RECORD DRAWING

ONONDAGA COUNTY - DWEP
CLINTON CSO STORAGE FACILITY

ONONDAGA COUNTY • DEPARTMENT OF WATER ENVIRONMENT PROTECTION
 CLINTON CSO STORAGE FACILITY PROJECT

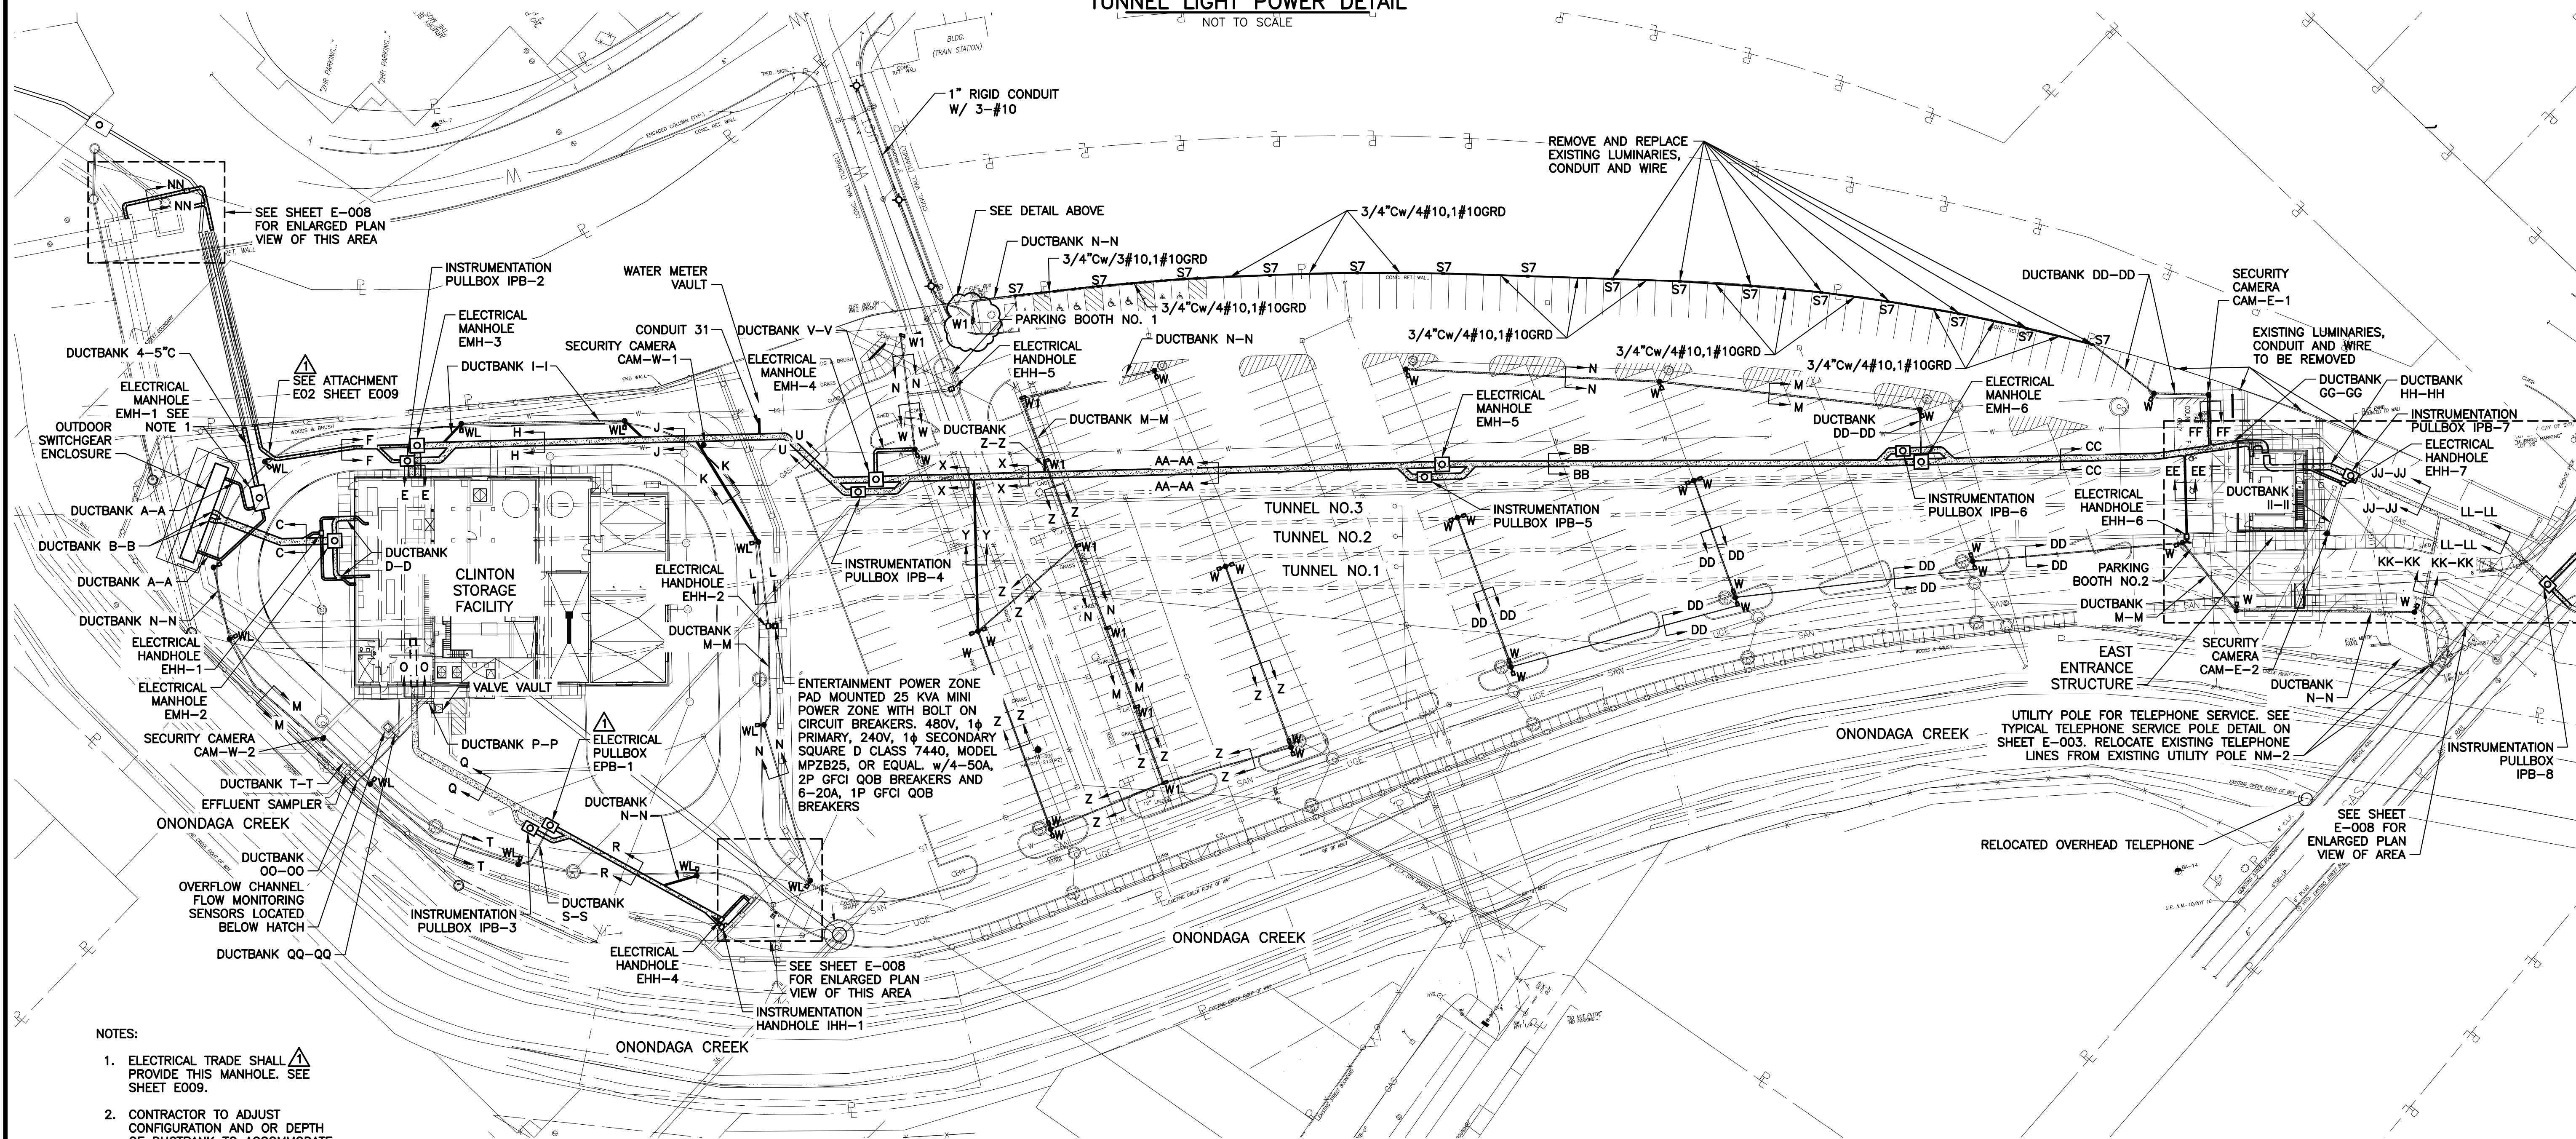
FO 45
SEE DRAWING E-009A FOR REVISED PLAN INCLUDING DUCTBANK CHANGES.

THE FEEDS FOR THESE TWO POLE MOUNTED LUMINARIES FROM EMH-3 IS ACCEPTABLE.

POWER AND SIGNAL FOR SECURITY CAMERA W-2, VIA DUCTBANK OO-OO IS ACCEPTABLE.

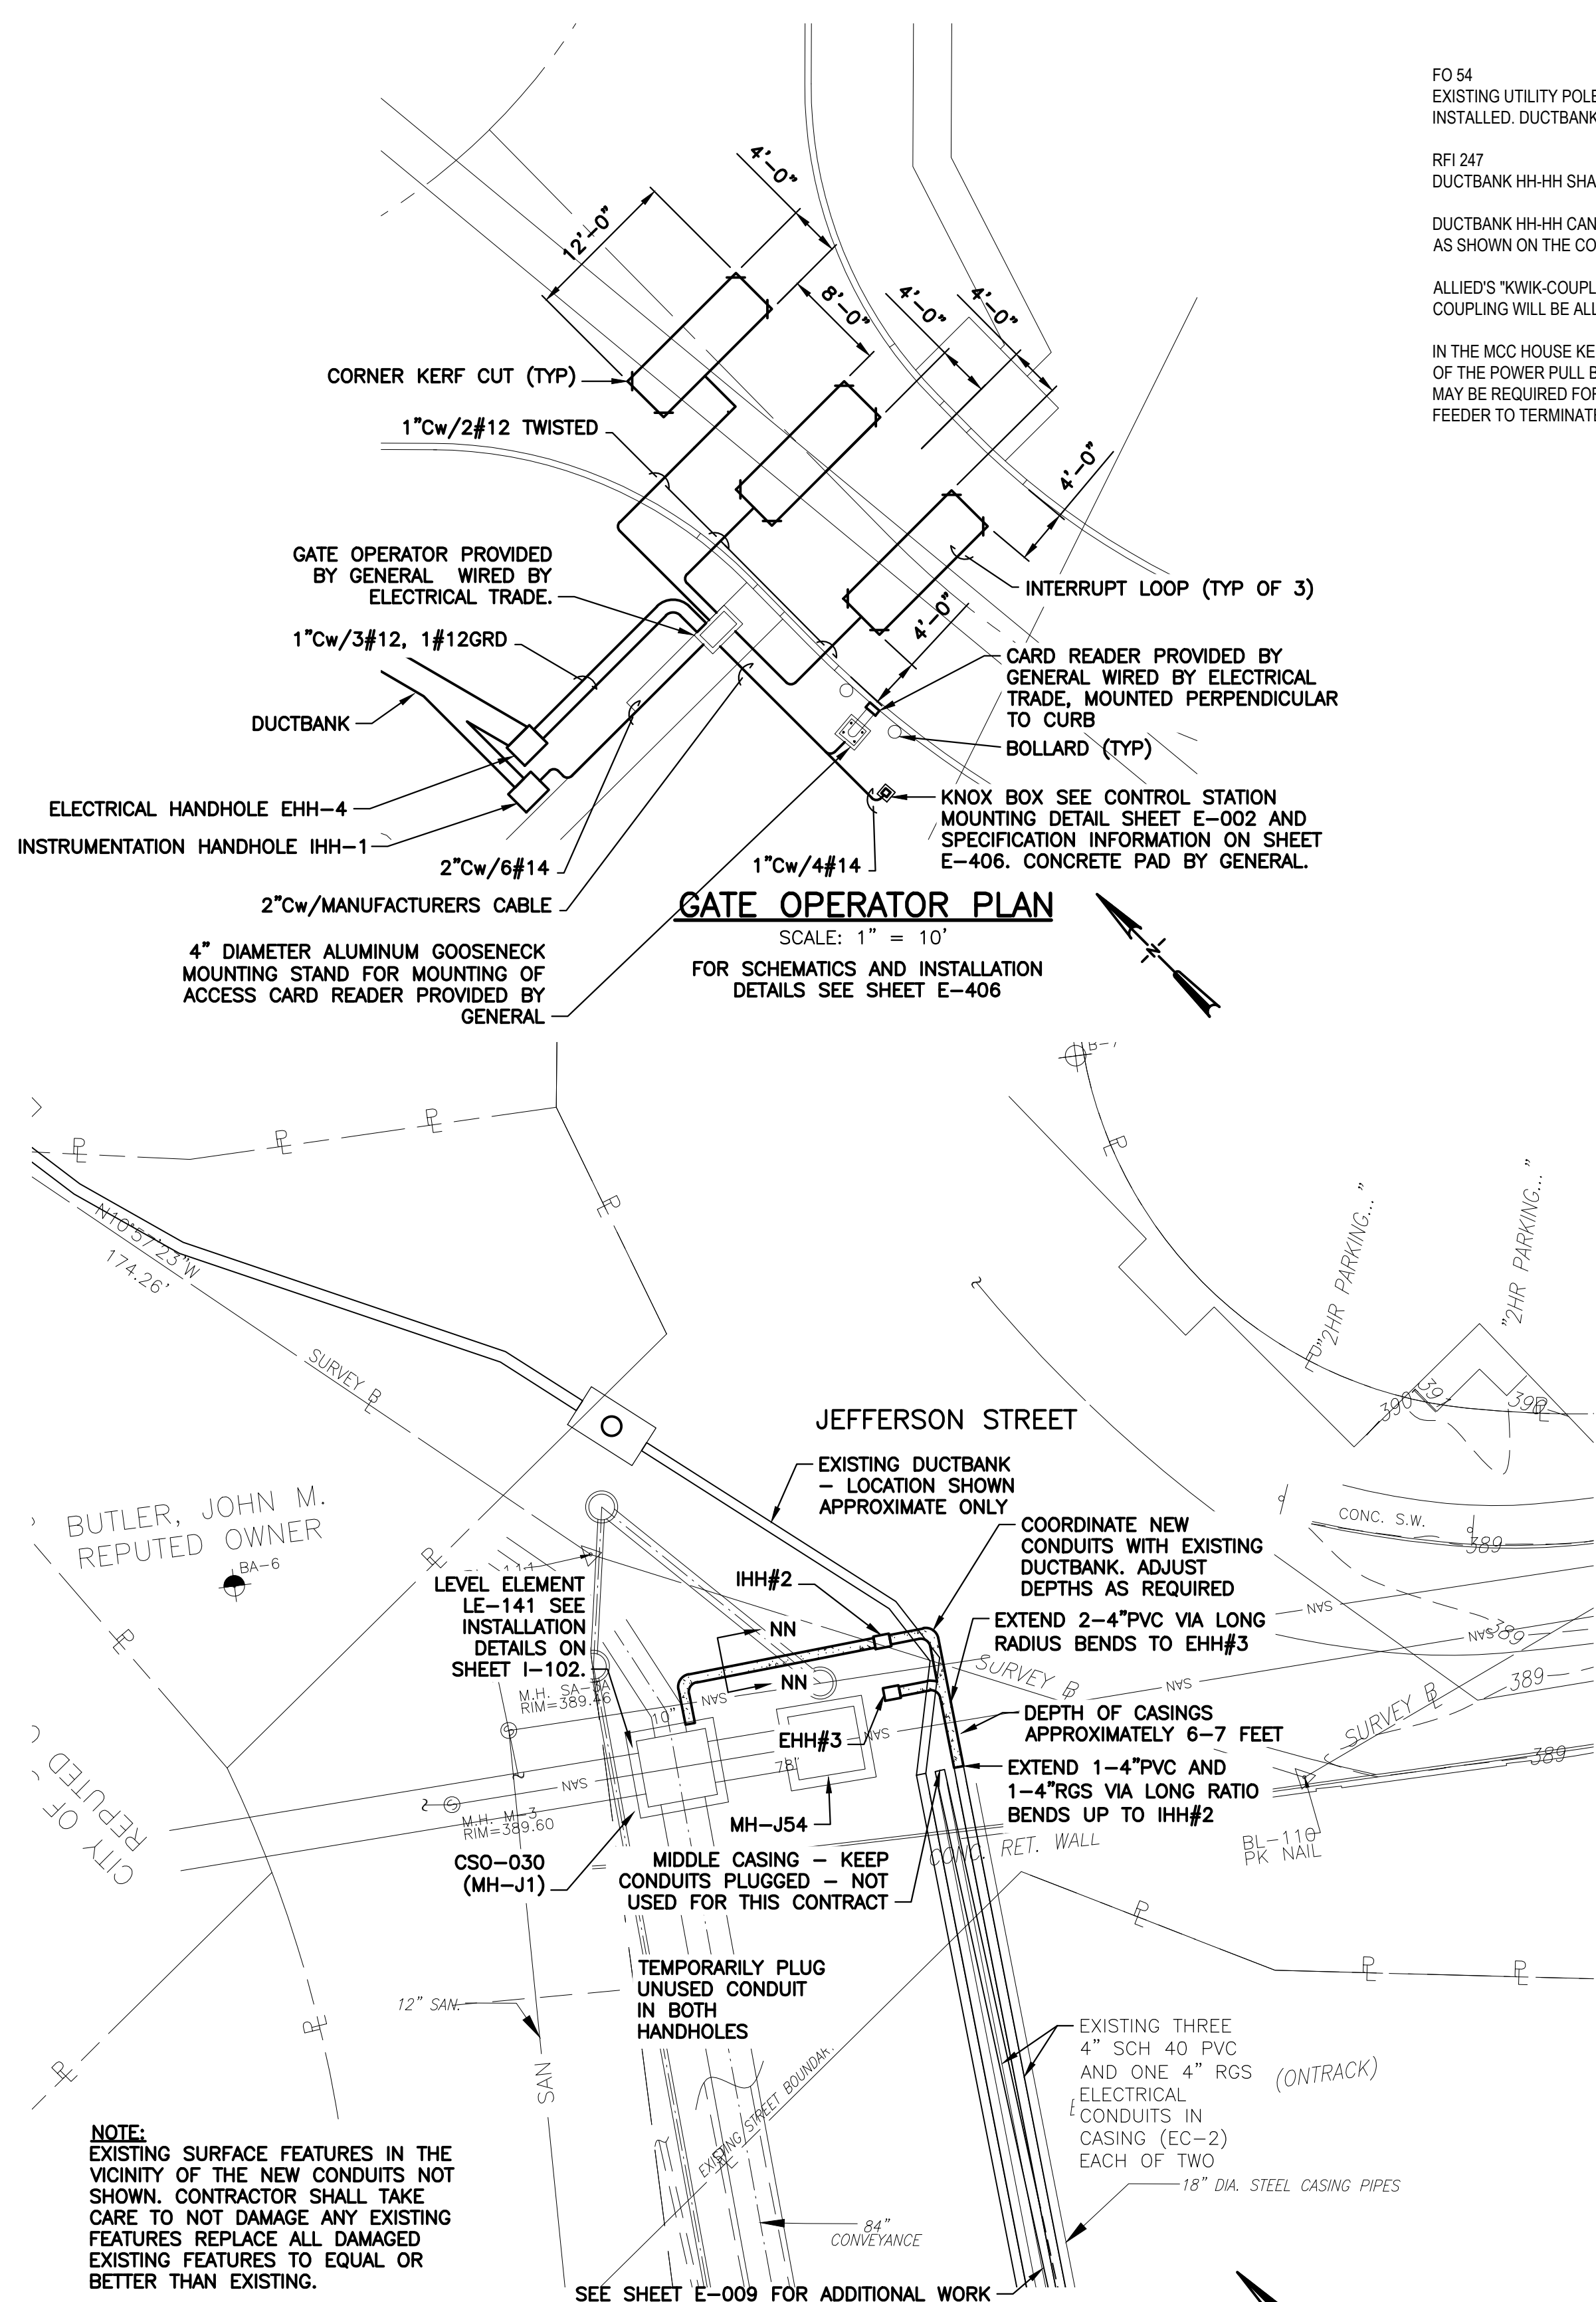
RFI 247
DUCTBANK HH-HH SHALL REMAIN AS SHOWN ON CONTRACT DRAWINGS.

DUCTBANK HH-HH CAN BE BROUGHT UP VERTICALLY NEXT TO DUCTBANK GG-GG,
AS SHOWN ON THE CONTRACTOR'S SKETCH SUBMITTED WITH THIS RFI.

ALLIED'S "KWIK-COUPLE" COUPLINGS AND ELBOWS OR BOLTED SLEEVE TYPE
COUPLING WILL BE ALLOWED. THE LATTER SHALL HAVE JOINTS FULLY TAPED.

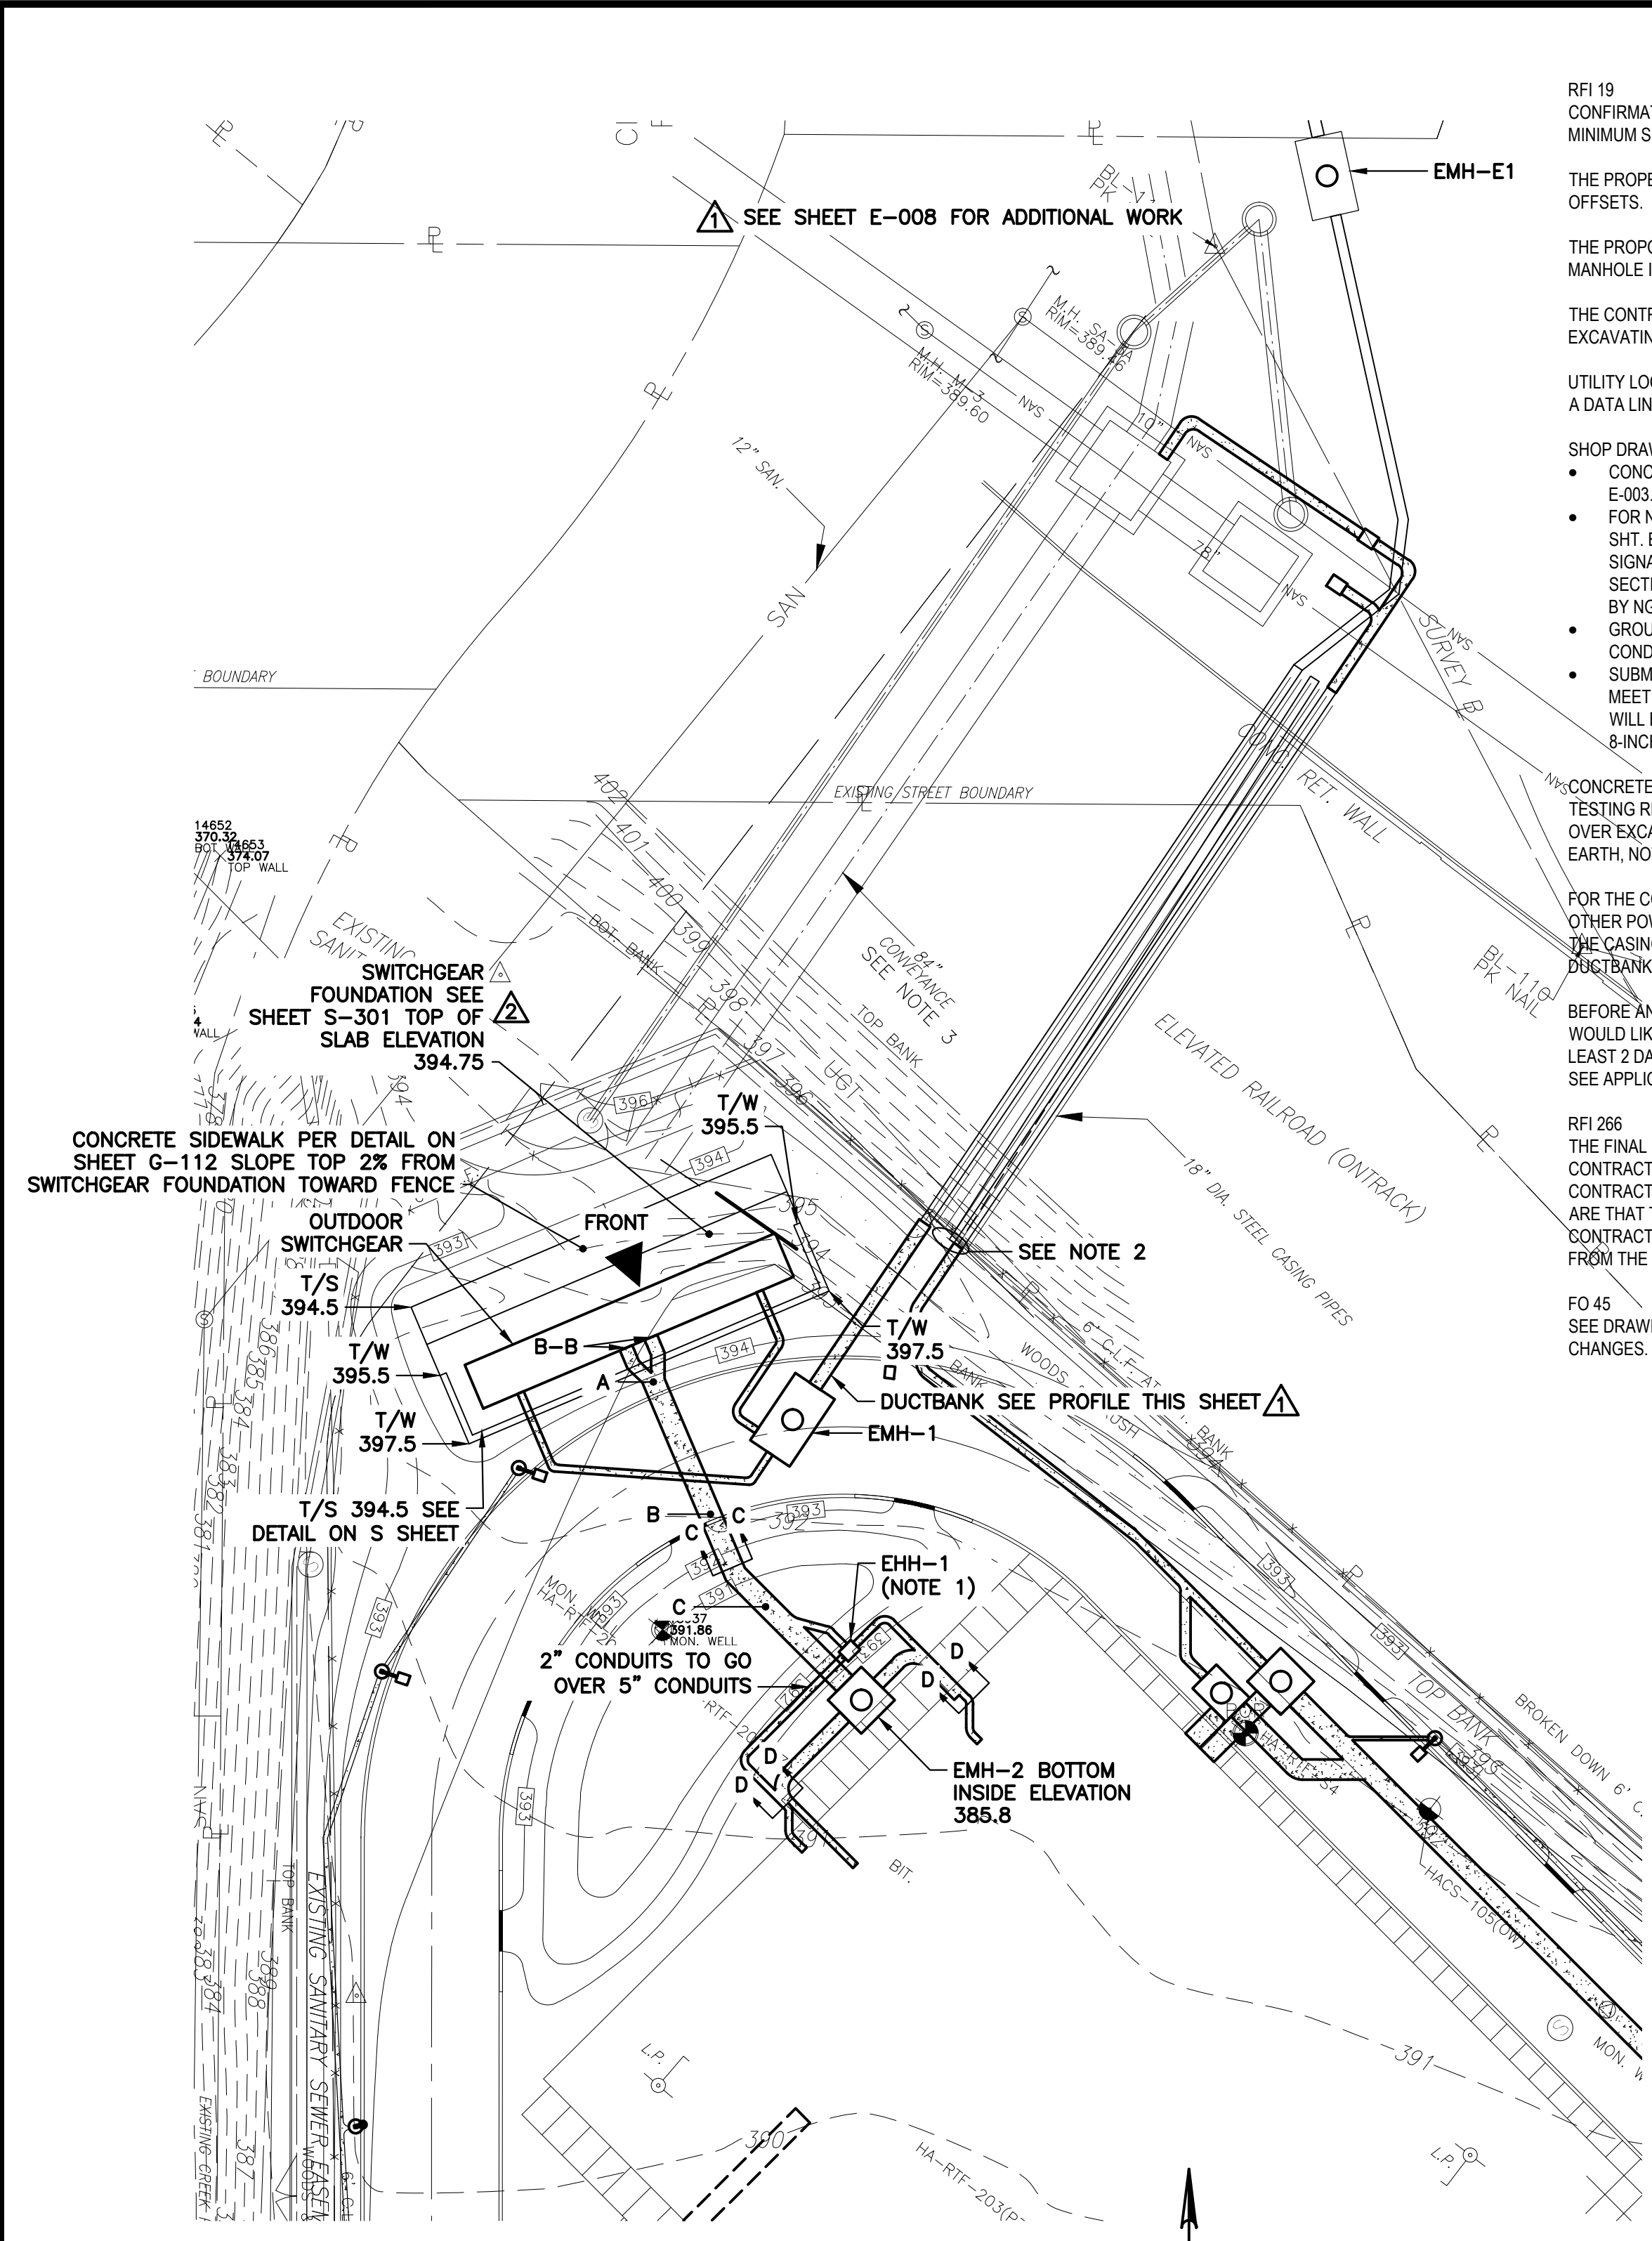
RFI 266
THE FINAL LOCATION OF THE SWITCHGEAR PAD SHOULD BE CONTRACTOR FIELD LOCATED WITH INPUT FROM THE ELECTRICAL CONTRACTOR AND NATIONAL GRID. THE ENGINEERS REQUIREMENTS ARE THAT THE PAD BE LOCATED IN THE GENERAL LOCATION SHOWN ON CONTRACT DRAWINGS G-106 AND E-009 AND THAT THE 4 FT SETBACK FROM THE CURB IS MAINTAINED AS INDICATED IN FIELD ORDER 47.

FO 45
SEE DRAWING E-009A FOR REVISED PLAN INCLUDING DUCTBANK CHANGES.
